**RTCA Special Committee 186, Working Group 3**

**ADS-B 1090 MOPS, Revision A**

**Consolidated List of Comments Received Against  
The Plenary Draft of DO-260A**

Consolidated Comments on the Draft 1090 MOPS (DO-260A)  
RTCA Paper No. 012-03/SC186-203

**Figure P-25: Effects of Transmitting Aircraft Altitude (A3-A2, LA2020-[24k]) on State Vector**

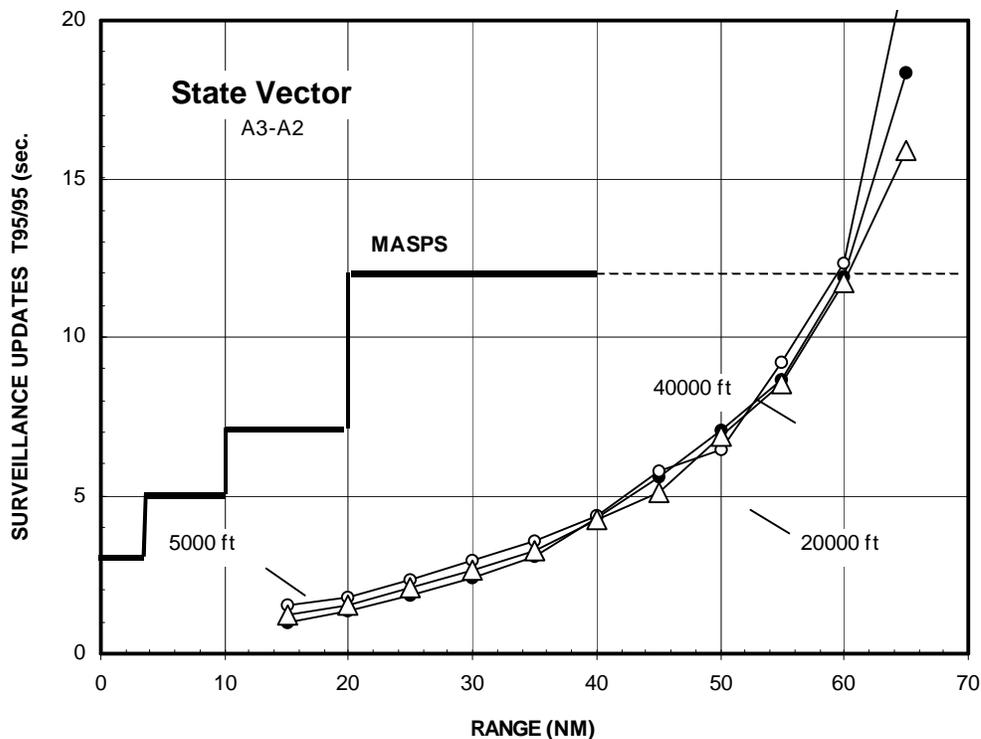
#	Original Comment		Section	Page	Comment	Suggested Resolution
	#	Author				
27	8	Bill Harman	P.3.3	P-33	<u>Altitude effects</u> . This wording is oversimplified. The small change in performance at shorter ranges can cause a more dramatic change in TSR range performance. Correcting this material is not critical, but might be useful to a reader who is interested in this detailed material.	See separate wording changes suggested including a revised figure in the attachment.  <b>WG-3 Response: Agreed</b>  <b>Done</b>
28	1	Pio Blankas	Appendix A, 1.4.5.7	A-22	In the paragraph after the note, TYPE codes 9 and 10 are incorrect for GNSS HAE	Change the TYPE codes to 20, 21 and 22.  <b>WG-3 Response: Agreed with Modification</b> WG-3 suggests adding a sentence in the last paragraph of A.1.4.5.7 to clarify, stating that: "For Format TYPE Codes 11 through 18, either GNSS HAE or altitude MSL will be used."  <b>Done</b>

Because the material in section P.3.3 is oversimplified, I offer the following rewording. Making this change is not critical, but it might be helpful to some readers.

The results for several values of transmitter altitude are shown in Figure P-25 and Figure P-26. The results indicate that performance is somewhat degraded when the transmitter is changed from 40,000 feet to 5000 feet. The degradation is more pronounced at shorter range, which seems reasonable because of the steeper elevation angles. Beyond 50 NM, performance is not changed significantly.
